FMC Corporation
Recreational Vehicle Division
333 Brokaw Road Box 664 Santa Clara, California 95052

Service Bulletin

NUMBER 2903 30002

REPLACEMENT OF
HINGED-TYPE AC
CONDENSER COVER
WITH BOLTED-TYPE
COVER

FIGURE 1. A/C COVER INSTALLATION

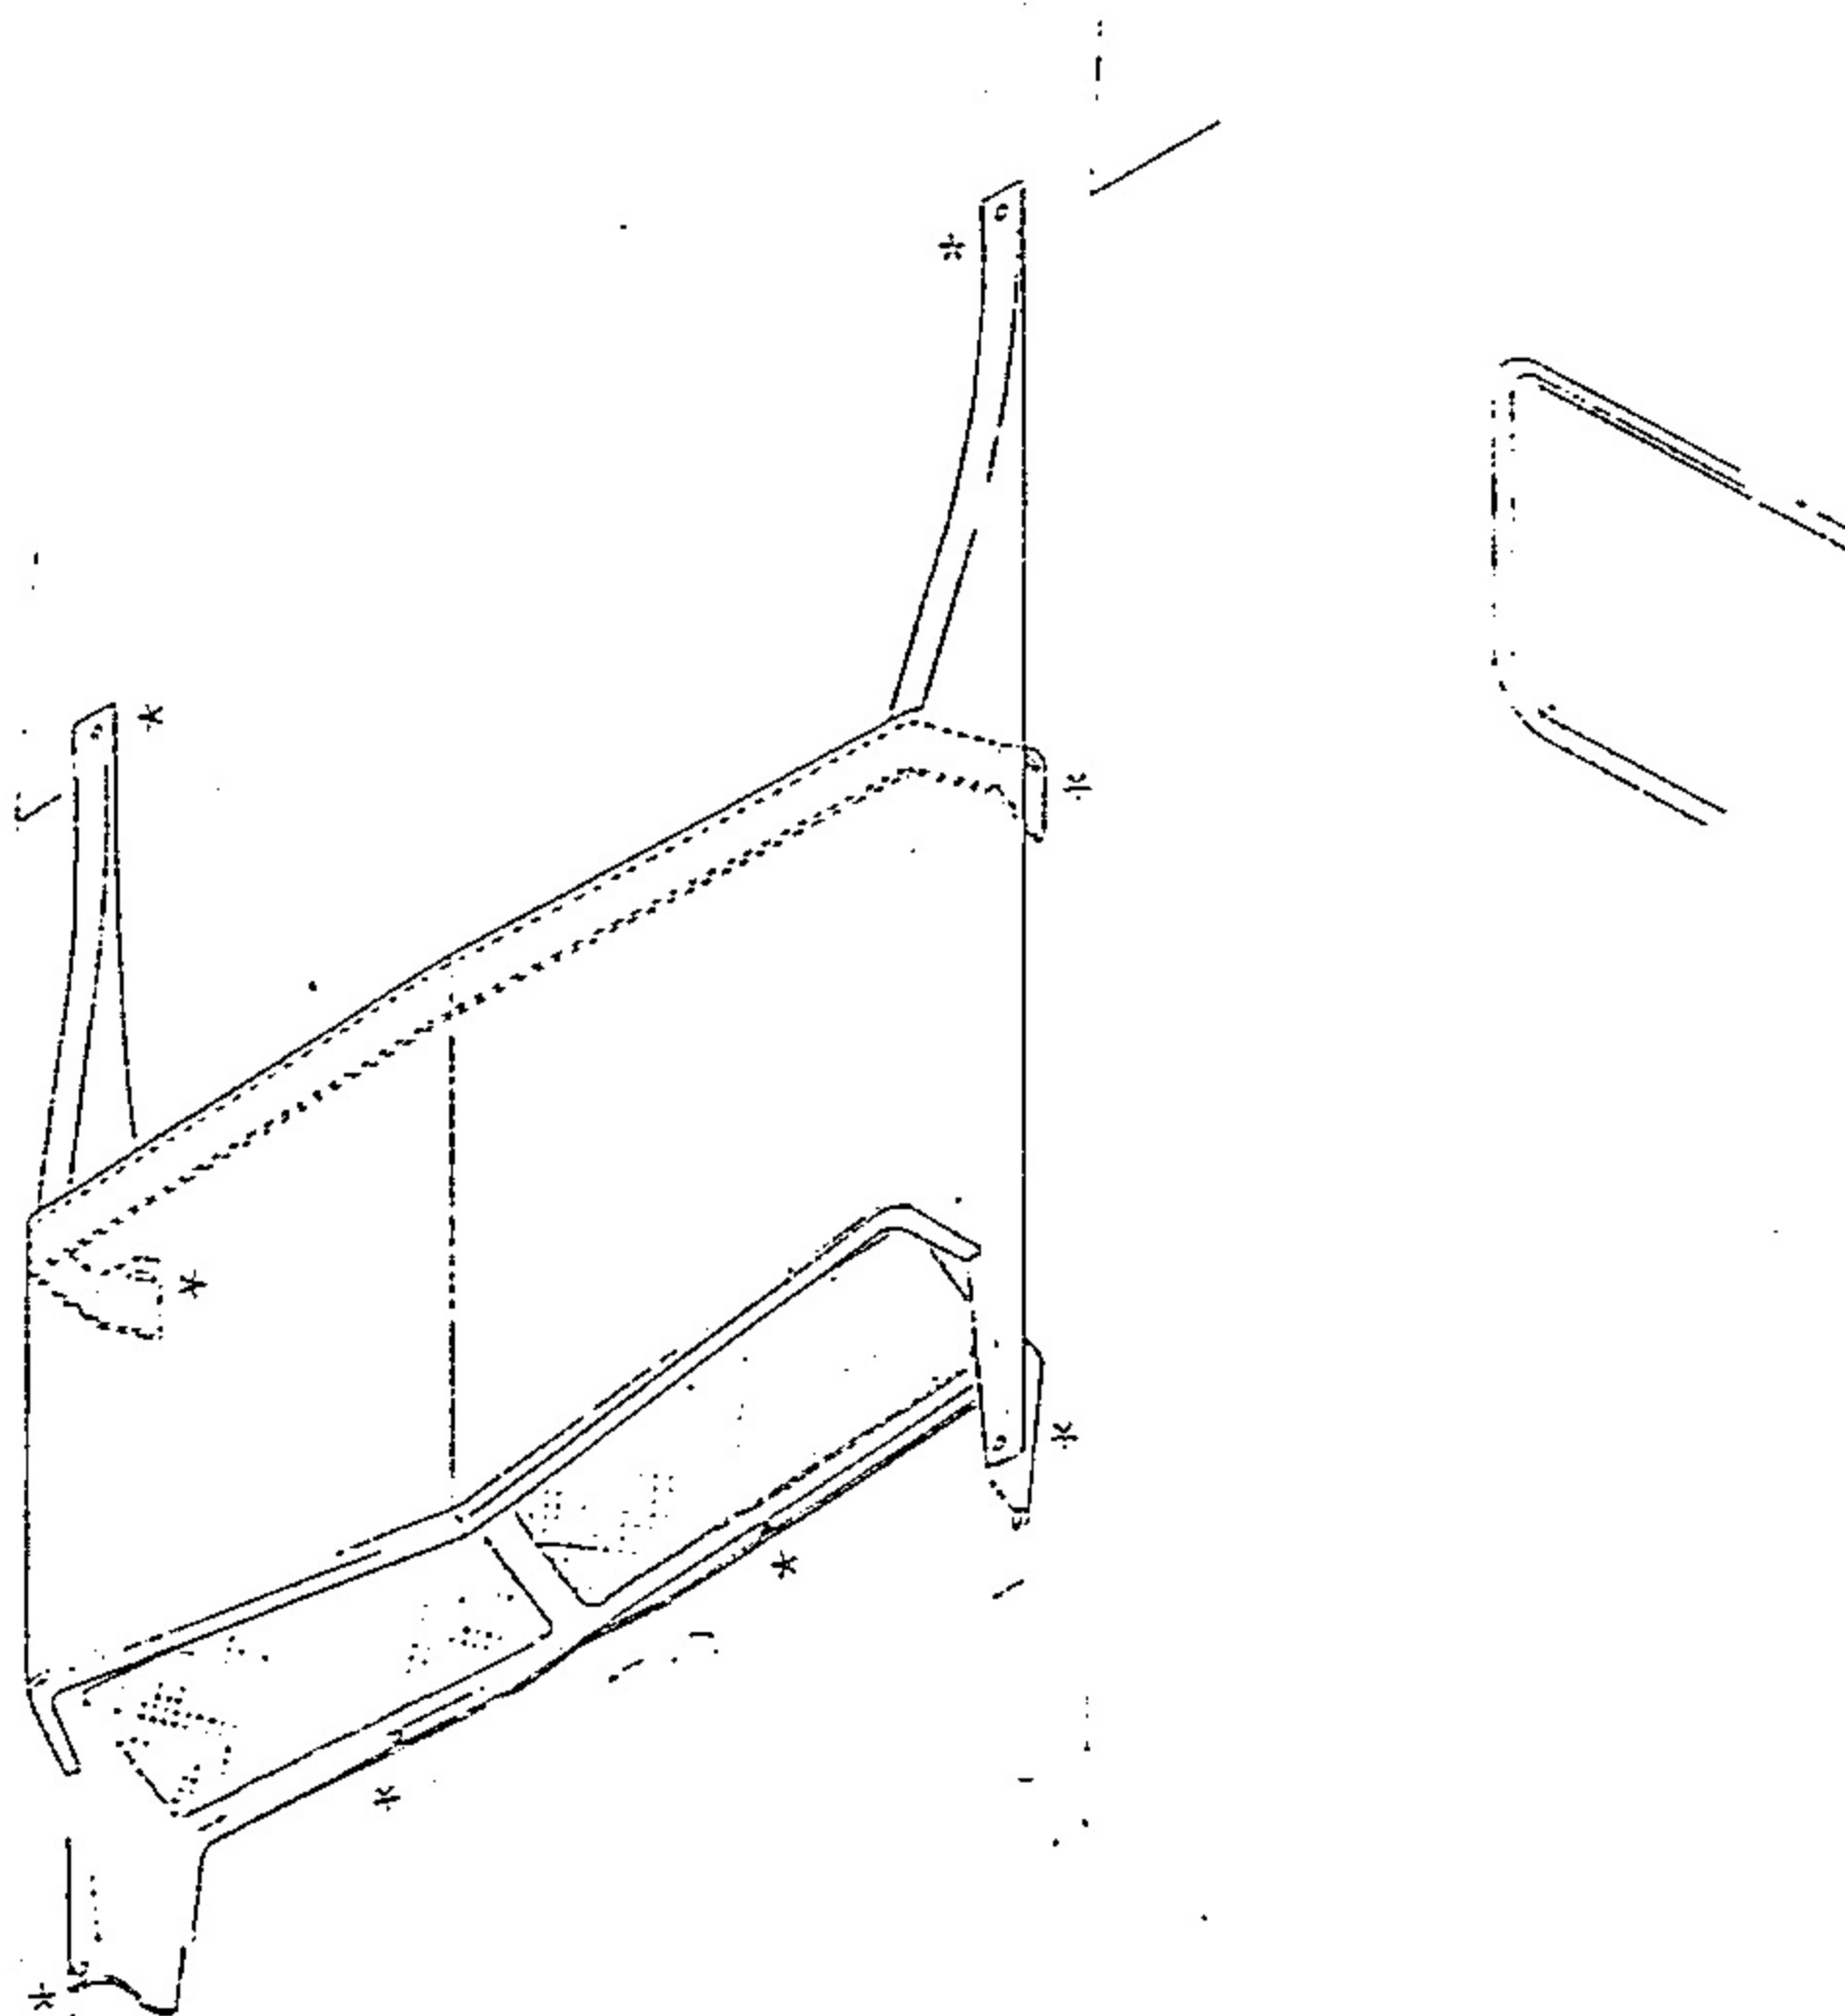
5. <u>ACCOMPLISHMENT INSTRUCTIONS</u> The procedure for installing the bolted-type condenser cover assembly (P/N 5101356-M01) is as follows: a. Locate cover assembly by centering between two roof fairings and over condenser as illustrated in figure 1.

*Drill eight (8) places per instructions. Center cover assembly inside two roof fairings and over condenser.

ATTENTION: SERVICE MANAGERS	GROUP 3
<p>b. Using holes in cover assembly (8 places per figure 1) as a template, drill through roof (fiberglass only) with 9/32 inch diameter drill bit.</p> <p>CAUTION</p> <p>Do not drill beyond outer fiberglass shell thickness to avoid damage to interior lining material.</p> <p>c. Remove cover assembly and open up holes in roof to 7/16 inch diameter.</p> <p>d. Insert Jacknut M17146 ("molly" fastener) into each hole until anchor is flush with surface.</p> <p>e. Turn screw until snug in order to properly seat Jacknut M17146 ("molly" fastener), then remove screw.</p> <p>f. Position and align cover assembly and install screws with lockwashers (8 each) until tight as shown in figure 1.</p> <p><i>John L. Strever</i> JOHN L. STREVER Service Manager</p>	<p>SUBJECT</p> <p>REPLACEMENT OF HINGED-TYPE AC CONDENSER COVER WITH BOLTED-TYPE COVER</p> <p>MODEL (S) AFFECTED</p> <p>2900R</p> <p>(Factory Use Only) Information added to:</p> <p>OWNER MANUAL (S)</p> <p>SERVICE MANUAL (S)</p> <p>PARTS MANUAL (S)</p> <p>WARRANTY MANUAL (S)</p> <p>OTHER</p>
